Value Engineering Study

Final Report

VE Number: 202303

I-75 Widening, MP 20.2 to MP 28.851 Laurel & Whitley Counties

15

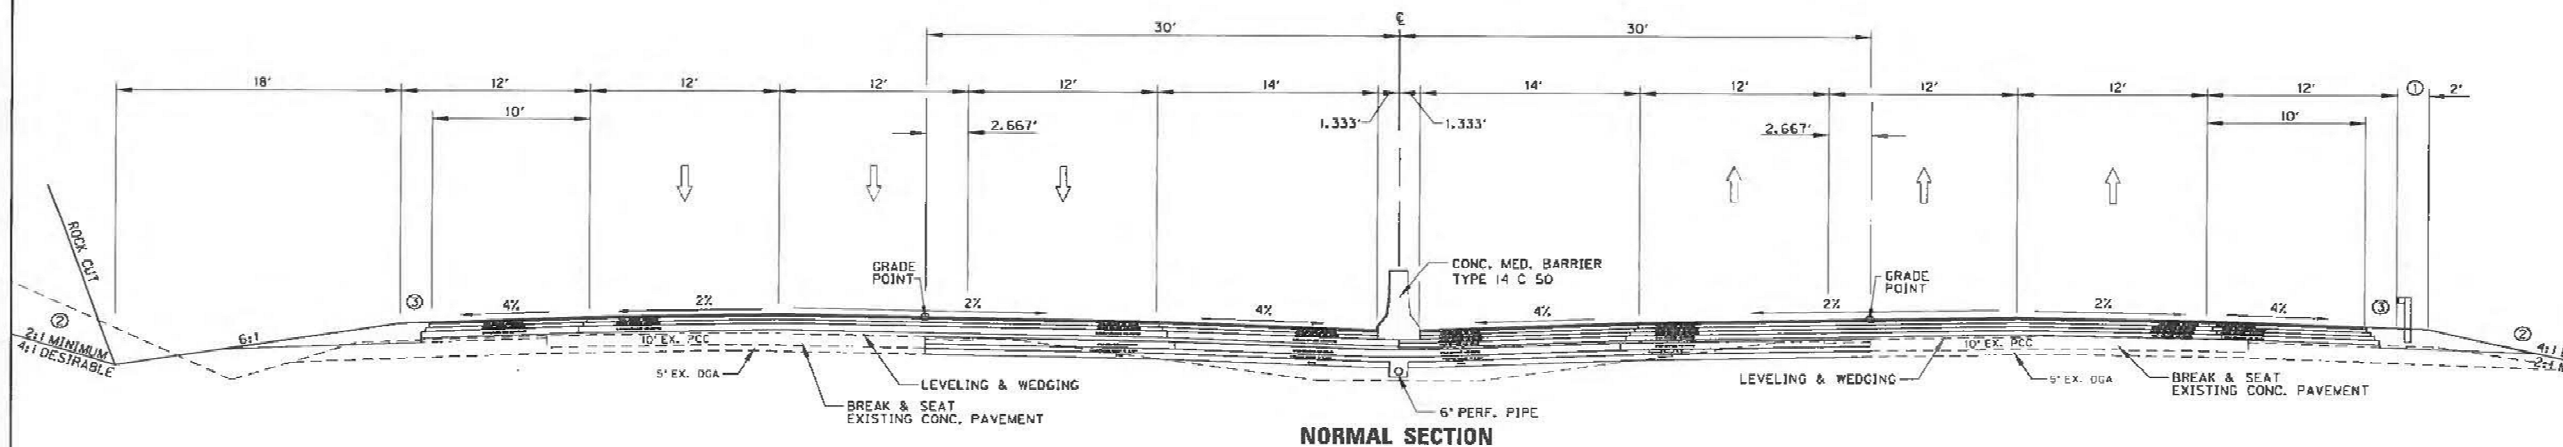
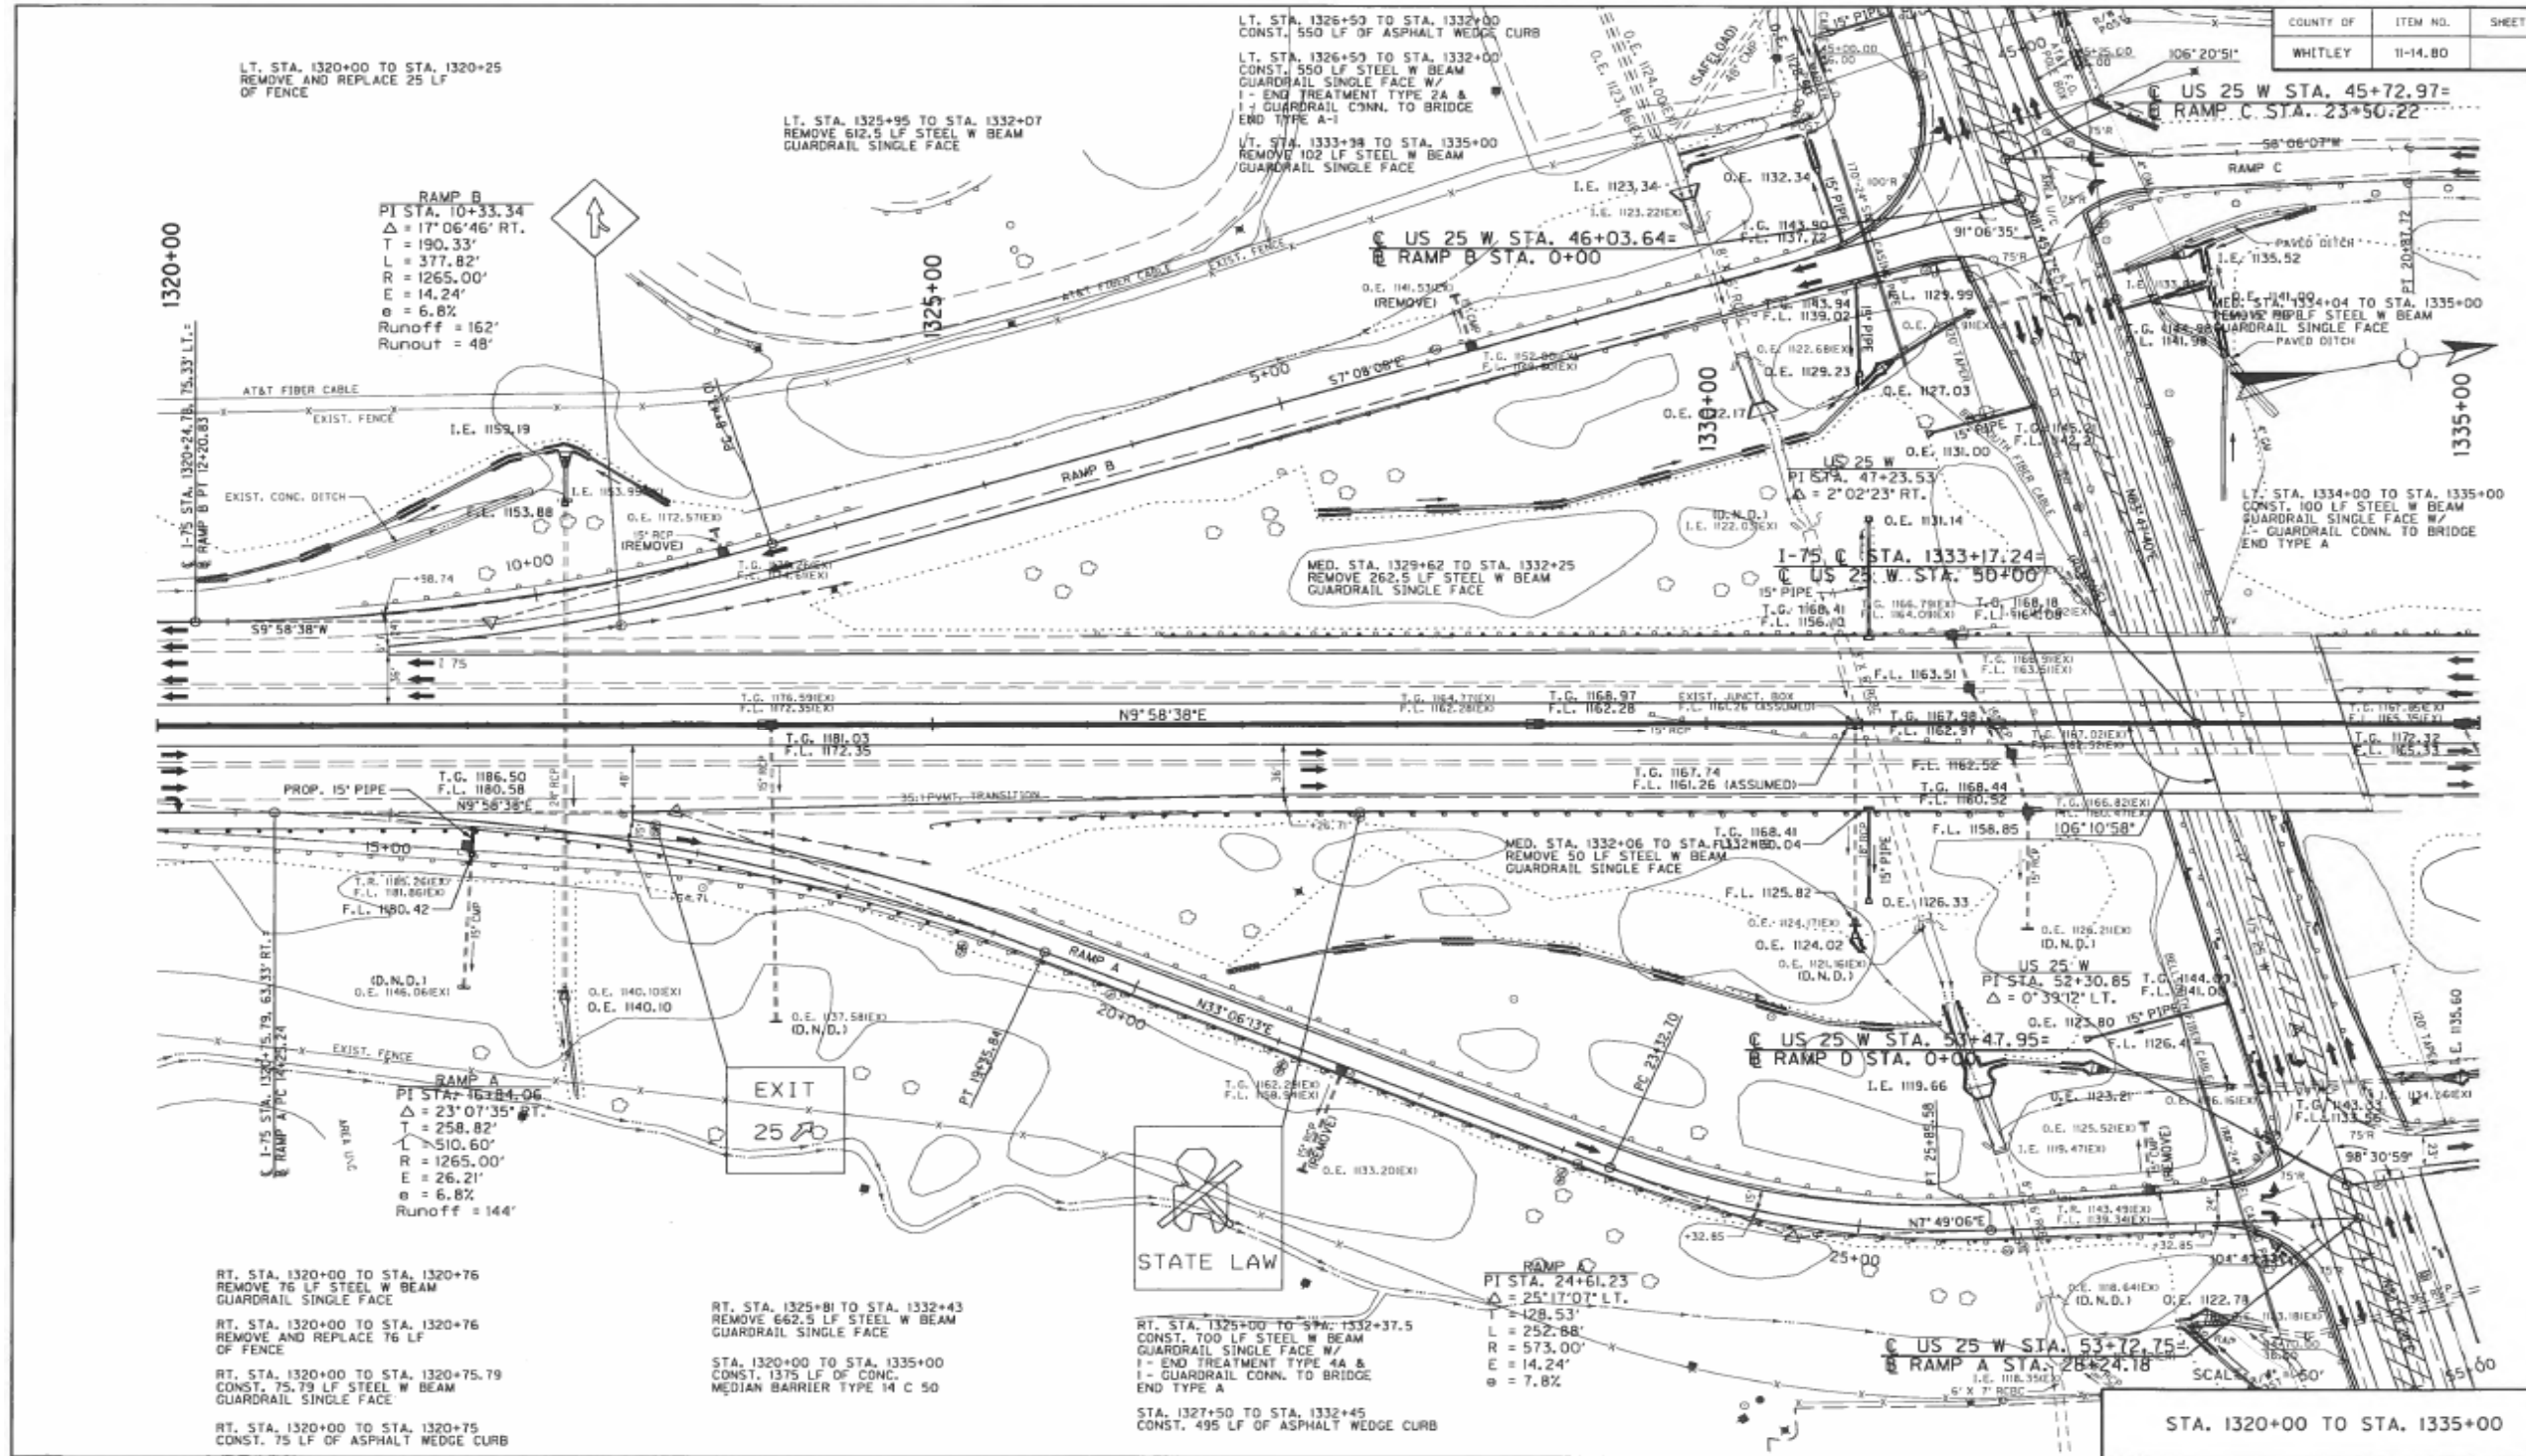
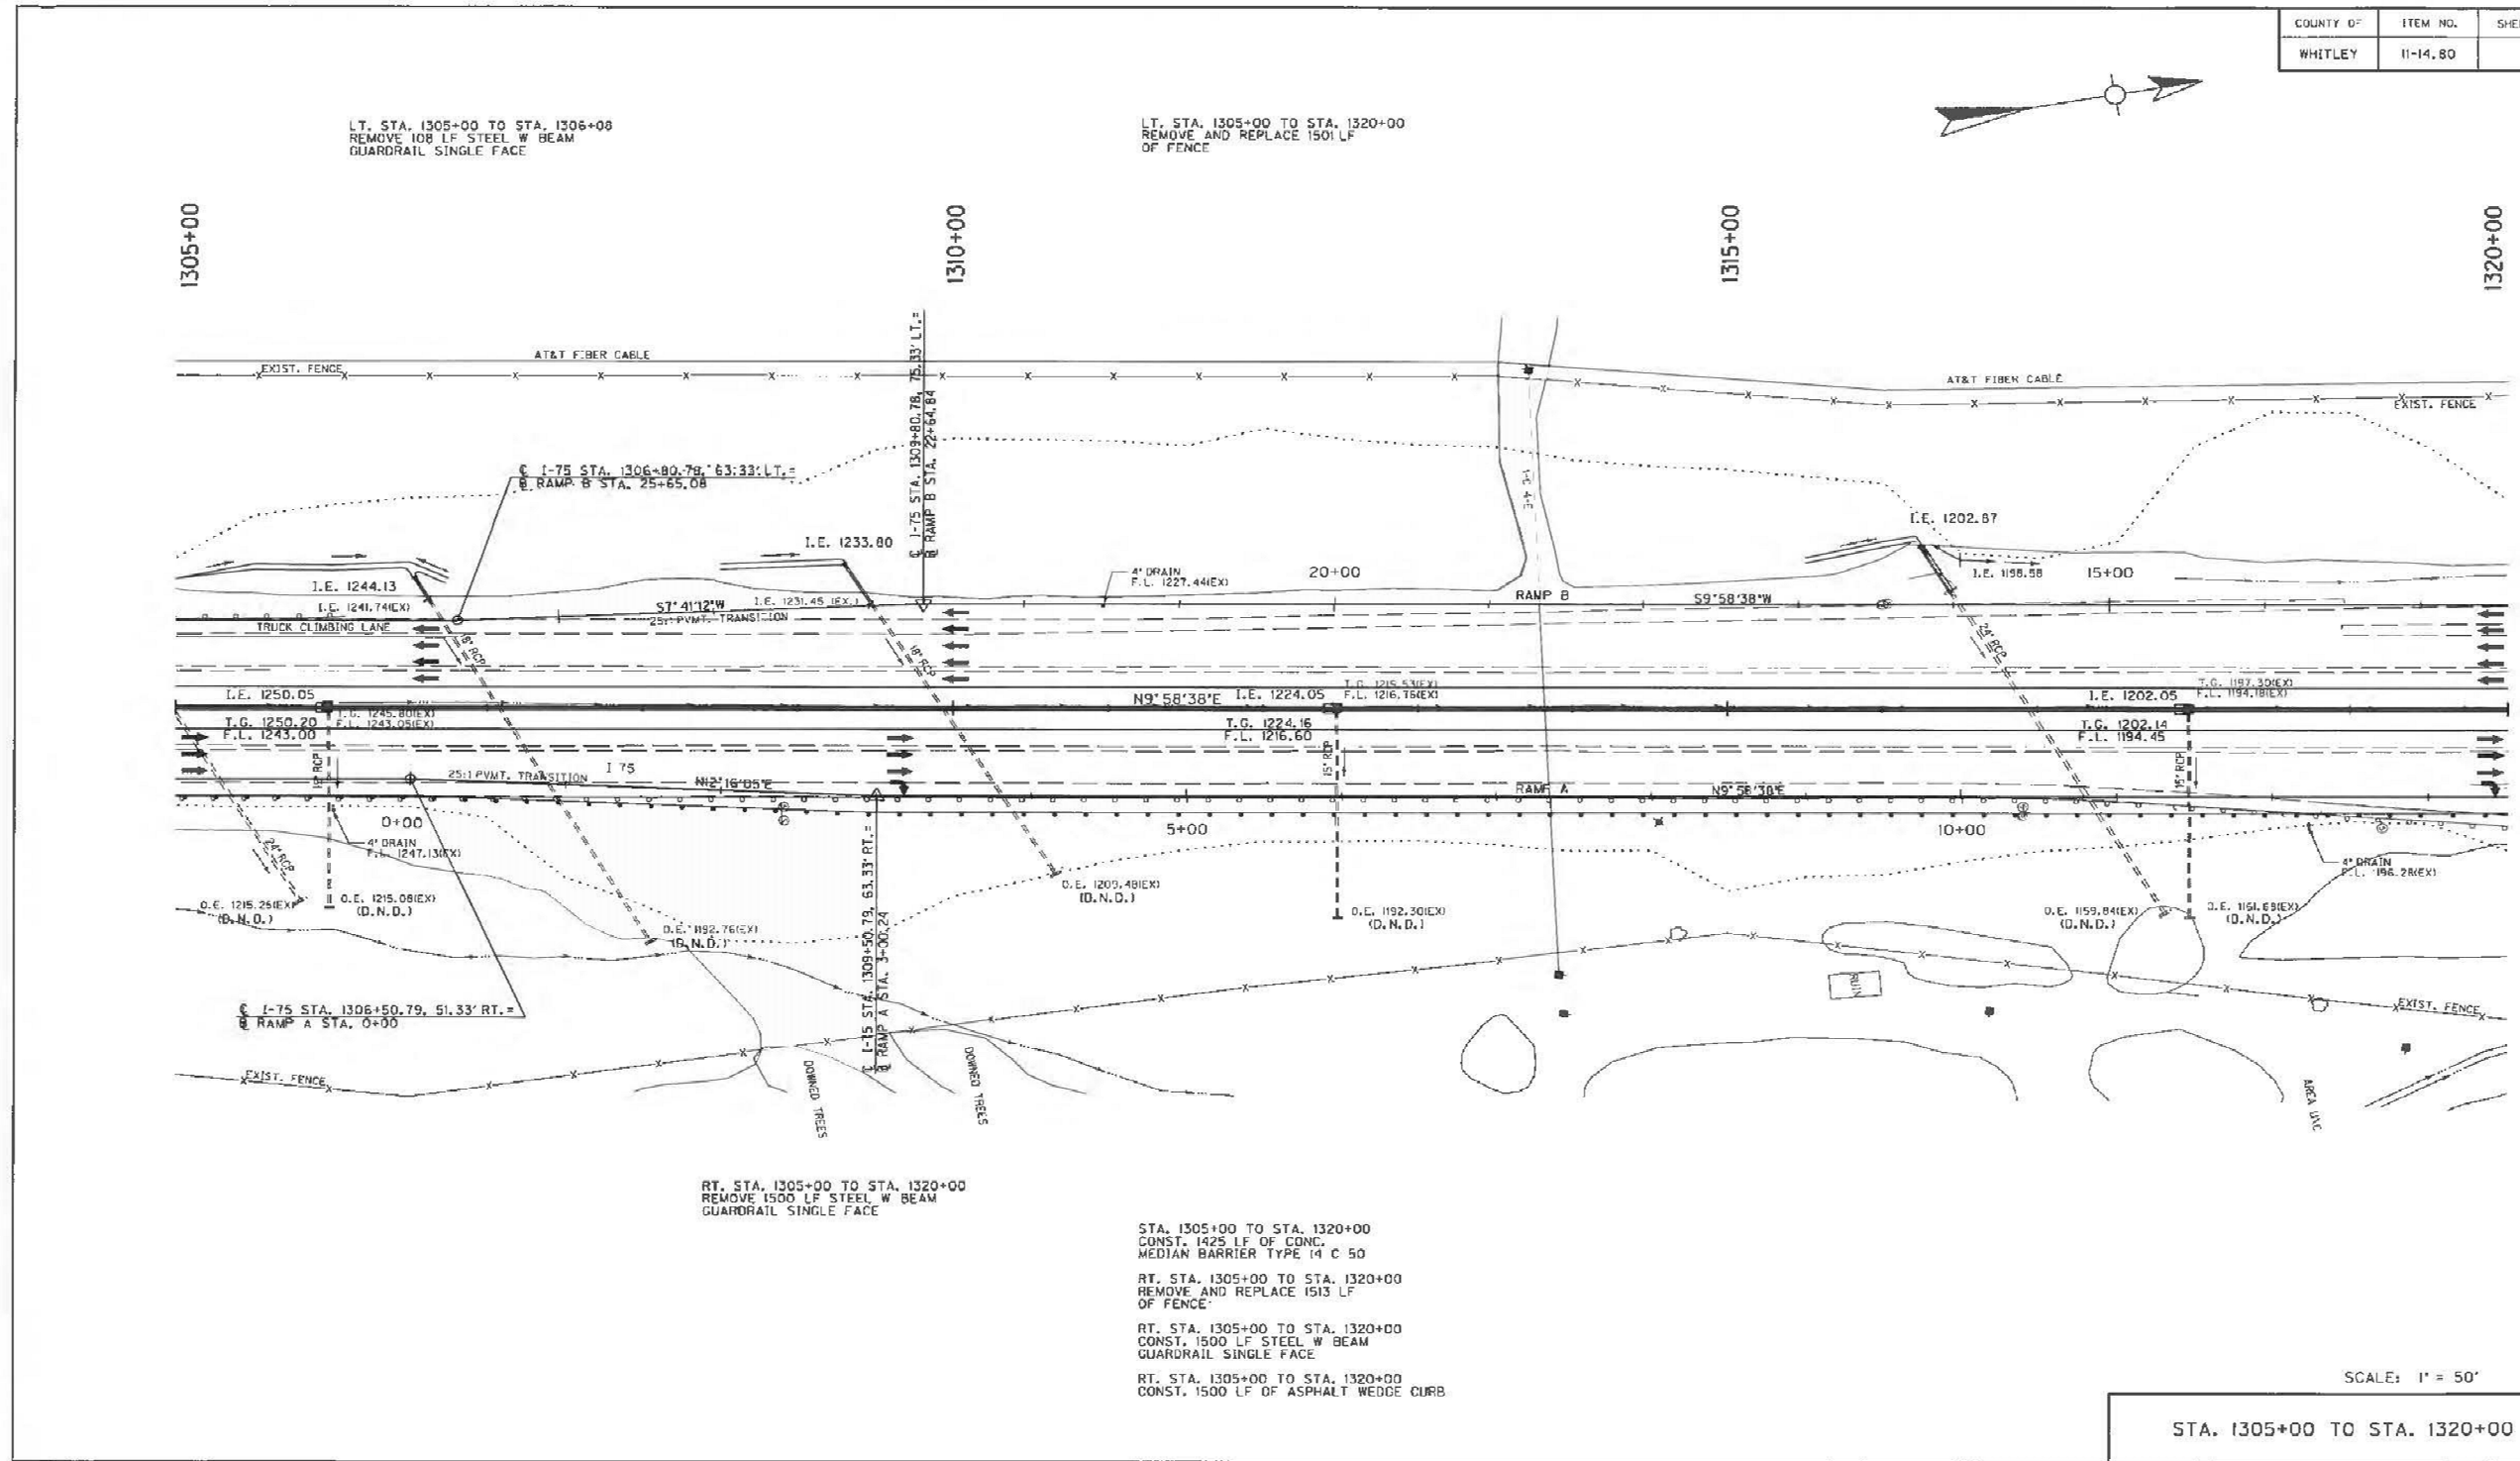
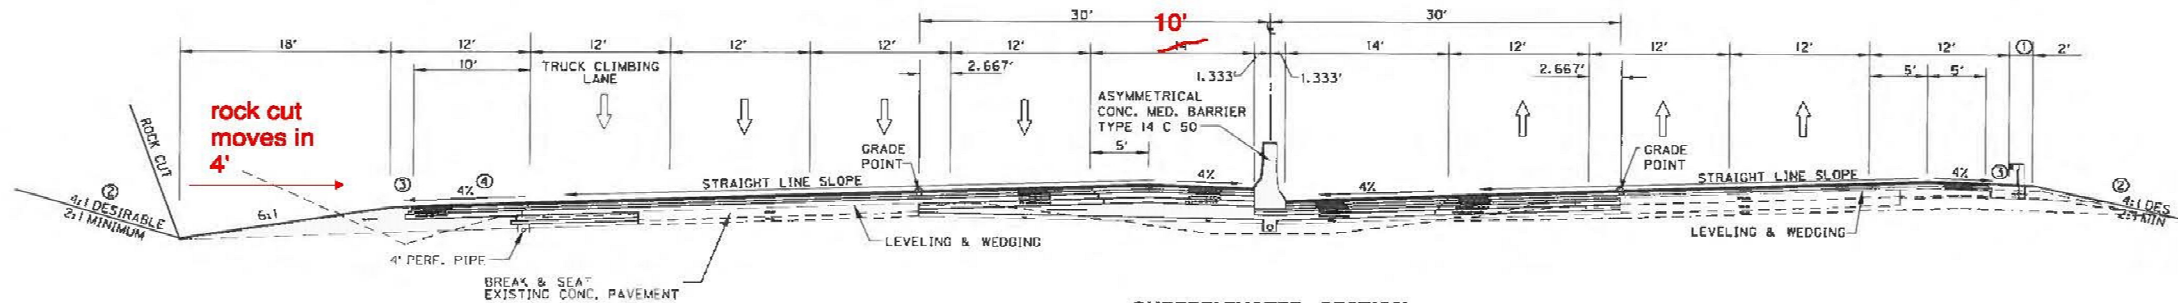
TITLE	At the truck climbing lane, use a 10' shoulder on the outside and an 8' shoulder on the inside to provide improved pull-off area on the outside shoulder, avoid rock cut, and provide for appropriately shaped truck climbing lane				
VALUE PROPOSAL SYNOPSIS:					
Avoidance of rock cut in the area of the truck climbing lane in order to maintain the truck climbing lane beyond the crest as required by federal standards for safety.					
 Reliability	Maintained	 Functionality	Maintained	\$ Initial Cost Avoidance (Add) \$941,000	
 O&M	Improved	 Schedule Impact	Improved		
BASELINE CONCEPT:					
The current configuration would maintain the truck climbing lane to the safe point, but would result in excessive rock cut on the outside shoulder.					
VALUE PROPOSAL DESCRIPTION:					
The value proposal would allow all federal guidance to be followed for shoulder widths and length of lane while greatly reducing or eliminating the need for rock cut on the outside southbound shoulder.

TITLE	At the truck climbing lane, use a 10' shoulder on the outside and an 8' shoulder on the inside to provide improved pull-off area on the outside shoulder, avoid rock cut, and provide for appropriately shaped truck climbing lane
DISCUSSION & JUSTIFICATION:	
<p>I-75 southbound near the exit 25 entrance ramp is on a steep grade uphill along the main corridors. Couple that the fact that US 25W crosses under I-75, trucks entering southbound I-75 from exit 25 have a lengthy and steep path to try and get up to speed before entering I-75. Ending the truck climbing lane prior to the crest can leave trucks merging into 70 mph traffic at a less than needed speed causing a severe safety issue. However, this area just south of the exit consists of substantial rock cut. The rock in this cut does not appear to be of good quality and removal of any rock could propagate further into the cut section.</p>
